Access Compliance Report

Public Rights-of-Way

(Curb Ramps)

Intersection ID: 50467	Main Street: ARSENAL_CT	Cross Street: LENOX_POINTE_DR	Location: NW
ADA ID: CC365D709990	Ramp Type: BlendTrans1	Initial Pass/Fail: Pass	Overall Compliance: No
Severity Score: 0			
Codes/Mitigation Info/Possible Solution		Field Measurements/Component Compliance

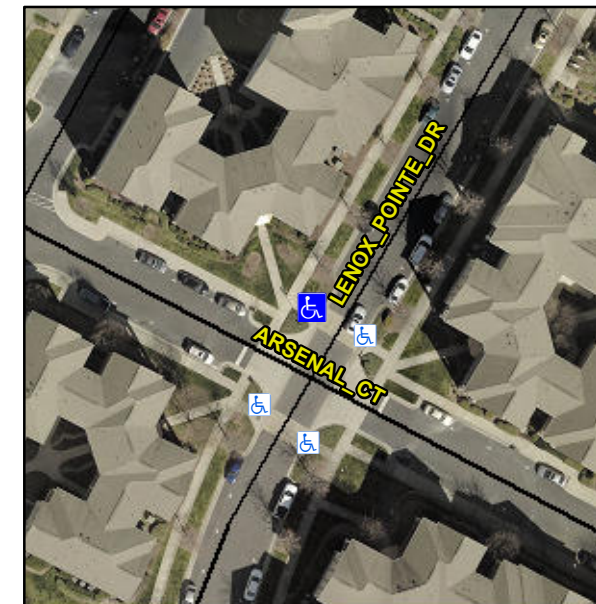
XWALK PAVERS, NO PAINT

Not Found, R304.2.2-Perp, R304.3.2-Para, R305.2

Compliance	Description	Data	Compliance	Description	Data
N/A	Ramp Length (in)	73.0	Yes	BlendTrans Slope (%)	4.5
Yes	Ramp Width (in)	48.0	Yes	BlendTrans XSlope (%)	1.6
N/A	Flare Type LT	Sloped	N/A	Flare Type RT	Sloped
N/A	Flare Slope LT (%)	6.1	N/A	Flare Slope RT (%)	3.7
N/A	Flare Traversable LT?	No	N/A	Flare Traversable RT?	No
Yes	Landing Length (in)	65.0	Yes	DWS Provided?	Yes
Yes	Landing Width (in)	72.0	Yes	DWS Contrast?	Yes
No	Landing Slope (%)	2.2	Yes	DWS Length (in)	24.0
Yes	Landing X Slope (%)	1.5	Yes	DWS Full Width?	Yes
N/A	Landing Curb? (Y/N)	No	No	DWS Offset (in)	5.0
N/A	Shared Landing?	No			
Yes	Gutter Ponding?	No	Yes	Gutter Slope (%)	2.3
Yes	Gutter Lip Ht (in)	0.0	Yes	Gutter X Slope (%)	1.1
N/A	Painted X Walk1?	Yes	N/A	Painted X Walk2?	N/A
	X Walk 1 Direction	To E		X Walk 2 Direction	N/A
	X Walk 1 Width (in)	144.0		X Walk 2 Width (in)	N/A
	X Walk 1 Slope (%)	0.3		X Walk 2 Slope (%)	N/A
	X Walk 1 X Slope (%)	0.9		X Walk 2 X Slope (%)	N/A

Yes	Ramp inside XWalk1?	Yes	N/A	Ramp inside XWalk2?	N/A
	Road Slope (%)	0.9		Clear Space?	Yes
	Road X Slope (%)	0.3	N/A	Clear Space to XWalk (in)	N/A
Yes	Any Obstructions?	No	Yes	Storm Grate/Utility Hazard?	No
	Obstruction Type			Storm Grate/Utility Type	
		N/A			N/A
			Yes	Surface Condition? (G/P)	Good
			No	Curb Slope (%)	13.7

Remove & Replace Curb Ramp With Two New Directional Ramps or Equivalent.
